December 22, 2023

**RE: Response to Data Request #1, PG&E Northern San Joaquin 230kV
Transmission Project (A.23-09-001)**

Figure 1.

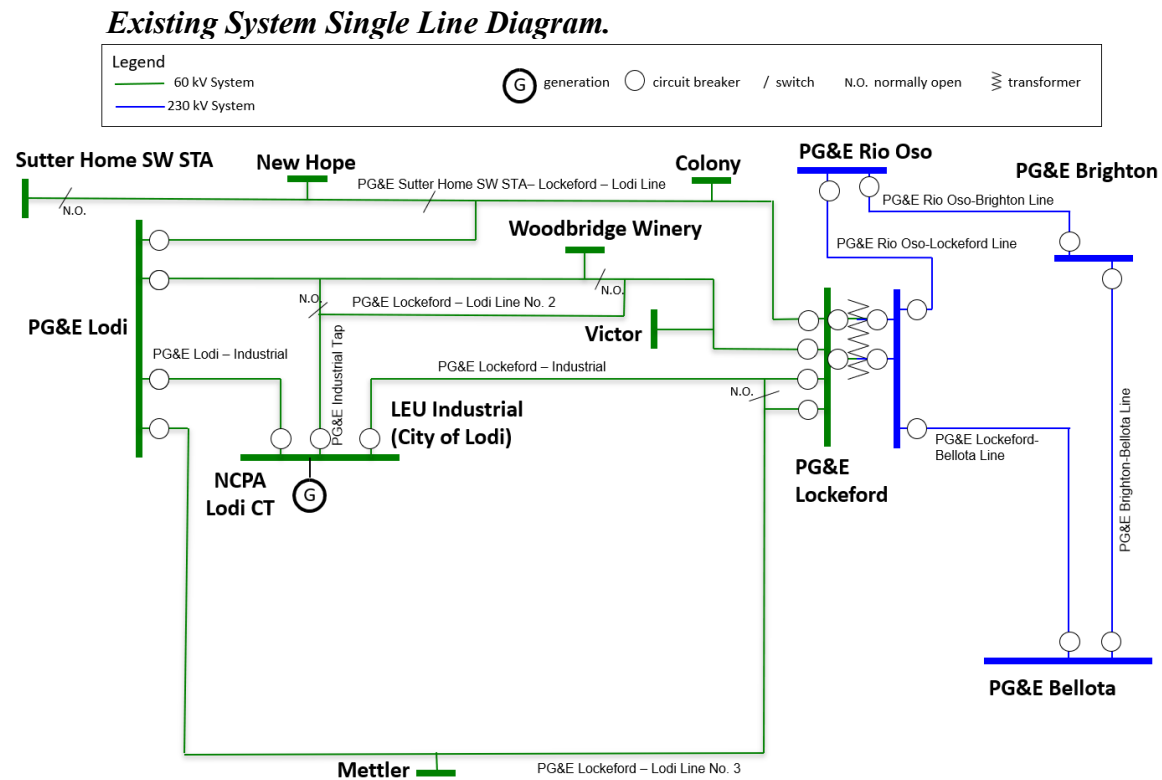
In PEA Section 4.4.10 "Distribution Energy Resources Improvement", the level of detail is not consistent with the other alternatives described in Sections 4.4.1 through 4.4.9 and 4.4.11. These other alternatives describe the type, size and location of the alternative considered. However, the description in Section 4.4.10 is: "This alternative would implement improvements to reduce electrical system demand (such as distributed generation, energy efficiency, and demand response)." Please provide a description of the size, type and location of distributed generation, energy efficiency, and demand response that comprises this alternative.

CAISO approved a 230 kV transmission project to address voltage issues and thermal overloads that can only be achieved through reducing load on PG&E's 60 kV transmission system serving the northern San Joaquin County/Lodi area, which is depicted on the Existing System Single Line Diagram in the PEA, and provided below as Figure 1.

LEU customers comprise the majority of the load on PG&E's 60 kV transmission system in the area, making LEU the primary target for solving the peak loading issues causing the thermal overloads and voltage issues. LEU receives power from three connections to PG&E's 60 kV system: the Lockeford-Industrial, Lodi-Industrial, and Industrial Tap 60 kV lines. Currently, LEU can also obtain local generation that is dispatched under emergency conditions from the Northern California Power Agency (NCPA) 25 megawatt (MW) Lodi Combustion Turbine (Lodi CT) within the City of Lodi through its connection at LEU Industrial Substation (CAISO 2017-2018 Transmission Plan, Appendix B). CAISO indicated that Lodi CT was modeled as offline in the 2017-2018 study cases in response to comments from City of Lodi and NCPA (2017-2018 TPP Stakeholder Comments – CAISO Responses). Demand by LEU customers is forecasted to increase, as discussed in Section C below, adding to existing reliability issues.

Accordingly, CAISO determined that resolving the thermal overload and voltage issues on PG&E's 60 kV transmission system under P1 contingency scenarios required shifting LEU's load off of the 60 kV system. In its final 2017-2018 Transmission Plan, CAISO called for
